ADA Curb Ramp New Construction Inspection Form (Perpendicular)

Nw287

24952.54

Nw mays

PERPENDICULAR RAMP (PR)

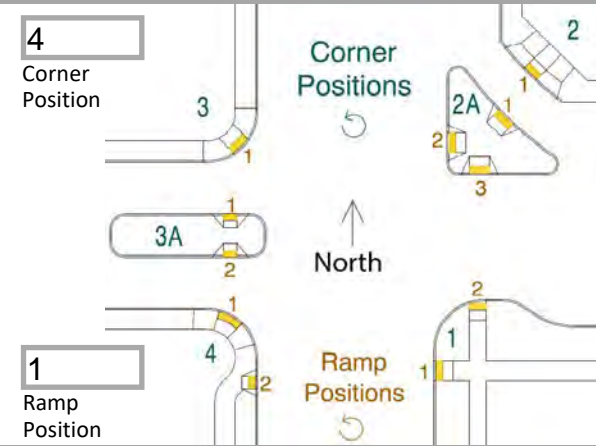
ICRR, DIFFERENTIAL SETTLEMENT
RR1/TS Crack
